Office Action Summary

10/561,915

JAN CHRISTOPHER MERENE

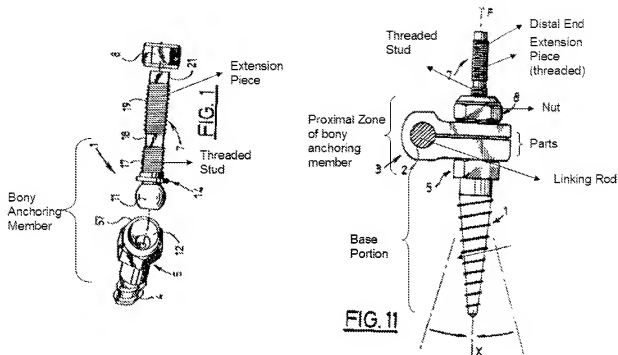
Claims 1, 13-14 recites "for running down connecting parts," where connecting parts has lack of preceding antecedent basis. For examining purposes, the examiner will treat "connecting part" as the part recited in claim 1, 13, 14. Regardless, the statement is unclear and indefinite since the extension piece rest on the threaded stud. The examiner will further treat this limitation as the part can engage the extension piece, where the part can "run down" along the extension piece and threaded stud and where the extension piece can engage a proximal zone of the bony anchoring member.

Claim 1 further recites "the proximal threaded stud of at least one anchoring member and the corresponding extension piece used with said bony anchoring member." It is unclear if the applicant is referring to another bone anchoring member or the same bone anchoring member. For examining purposes, the examiner will treat this limitation as the proximal stud of one bony anchor member, with an extension piece and a positioning member.
